Currituck County
Board of Adjustment Agenda
Historic Currituck County Courthouse
January 9, 2014, 7:00 p.m.

Subject: BOA 13- Zatloukal - Variance

Re: **Lot 246, Phase 3, The Currituck Club**
Variance Request Application
Corolla, Currituck County, North Carolina

RE: Lot 246 The Currituck Club
Response to Variance Request Application for Additional Lot Fill

SITE PLAN & PUMP STATION DETAILS

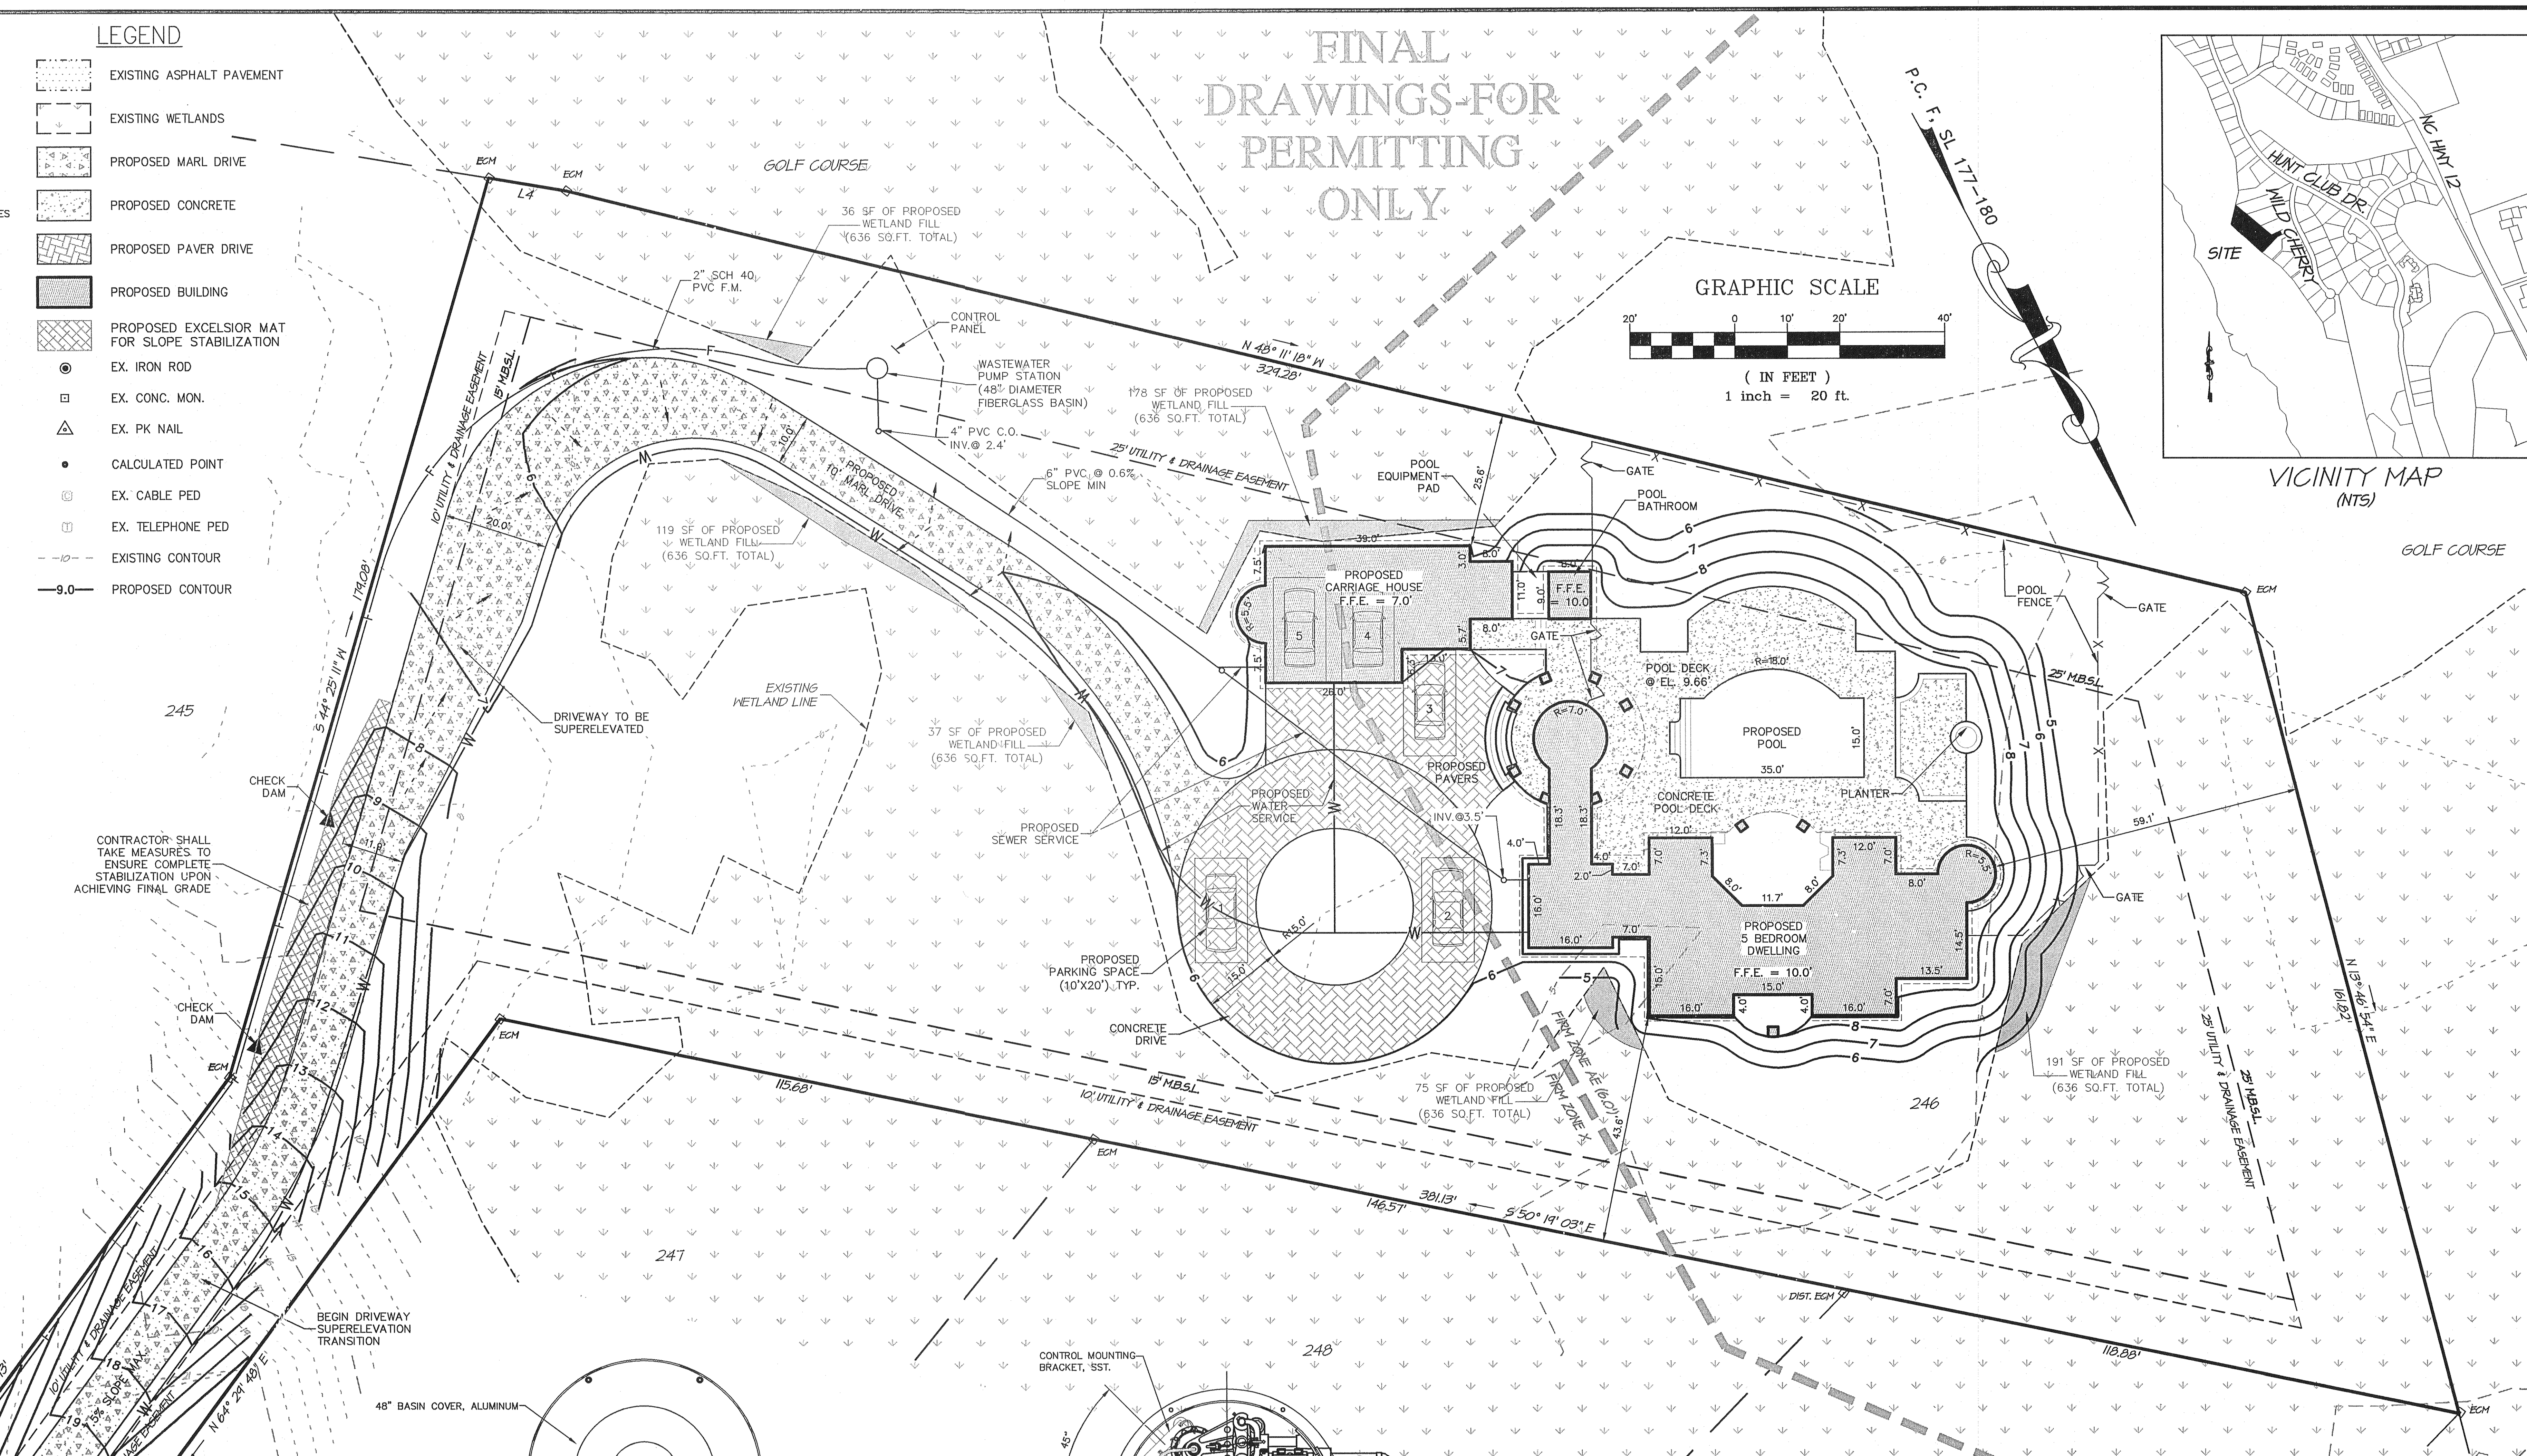
I have reviewed the above referenced Variance Application and Site Plan sealed on 12/2/13 and revised Site Plan sealed on 12/20/13 submitted by Quible and Associates. The purpose of the variance is to request additional fill on the lot above what is allowed in the UDO and Stormwater Manual.

The existing grades of the lot at the house pad are approximately 5' – 6'. The FEMA Zone of the lot is AE (6.0'). The regulatory flood protection elevation for the finished floor elevation (FFE) is 7'. According to the site plan, proposed elevations for the circular driveway and garage area is approximately 6' with a garage FFE of 7' and building pad elevation for the house is approximately 9' with a house FFE of 10'.

I have reviewed the variance requests and engineer's site plan. I visited the site on December 12, 2013. The following issues were analyzed.

- The proposed fill will not have a flooding impact to the neighbors with possible exception of the fairway to the south. The lot to the east is greater than 100' from the fill in question and is at the same relative elevation as the proposed lot fill. All other neighbors are much higher than the proposed fill.

- Requiring the lot to manage a 4" rain event to capture runoff from the fill will not provide any benefits. Runoff from the fill area will drain to existing wetlands which serve as a recharge area and a flood mitigation measure. I would not recommend disturbance to these areas. Any runoff from the lot is directed across the driveway toward the fairway to the south.

- The engineers have made modifications to the proposed driveway to prevent runoff from the driveway onto the neighbor and erosion control measures were added to provide additional stabilization due to concerns of the steep grades.

1. The property may be filled to establish a building pad at a maximum elevation of 9.5' (NAVD 1988).
2. The site must be built in accordance with the plans included in the variance application. Minor deviations may be permitted by staff that do not substantially modify the amount of fill, impervious surface, or stormwater/erosion control measures.
